April 2024 ERRATA for *Guide for the Planning, Design, and Operation of Pedestrian Facilities*, 2nd Edition (GPF-2)

AASHTO has issued an erratum, which includes technical revisions, for the *Guide for the Planning, Design, and Operation of Pedestrian Facilities*, 2nd Edition (GPF-2).

Figure 2-5. Relationships between Pedestrian Speed and Flow (TRB, 2016; adapted from Pushkarev and Zupan, 1977)

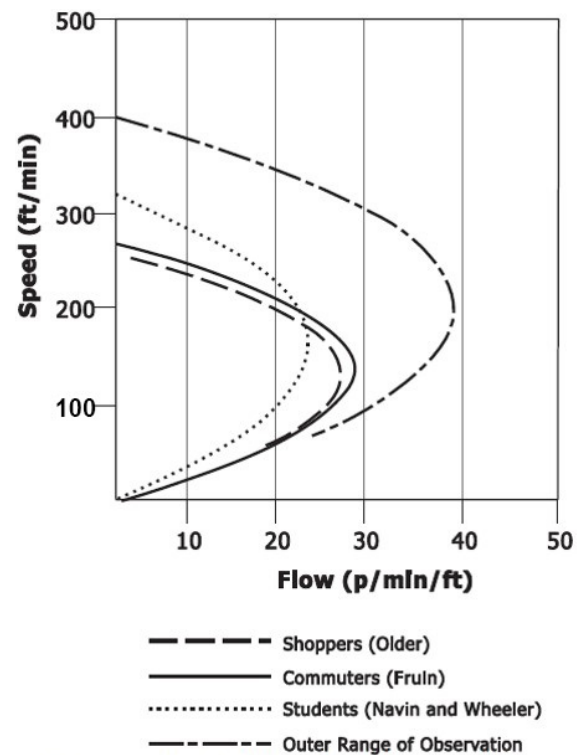
Original Page	Section	Existing Text	Corrected Text
2-7	Figure 2-5	In Figure 2-5, there are two instances of "200" on the y axis, Speed (ft/min)	The lower value is on the y axis is "100."
3-19	Figure 3-7	In Figure 3-7, "2 in." is the wrong dimension.	<p>The correct dimension is "2 ft" as shown below:</p>  <p>The diagrams illustrate the correct dimension of 2 ft for the walkway. Each diagram shows a walkway with a 1.0 ft (0.3 m Min.) width and a 42 in. Min. rail. The slope requirements and drop heights are as follows:</p> <ul style="list-style-type: none"> Diagram 1: Slope $\geq 1V:3H$ and $\leq 1V:2H$. Drop is 6 ft or more, or 4 ft next to water. Diagram 2: Slope $\geq 1V:2H$ and $\leq 1V:1H$. Drop is 4 ft or more. Diagram 3: Slope $\geq 1:1$. Drop is 1 ft or more.
3-47	Figure 3-27	One of the sidewalk dimensions is incorrect.	Of the two occurrences of "4.0 ft", the top one should be "5.0 ft" as shown below:
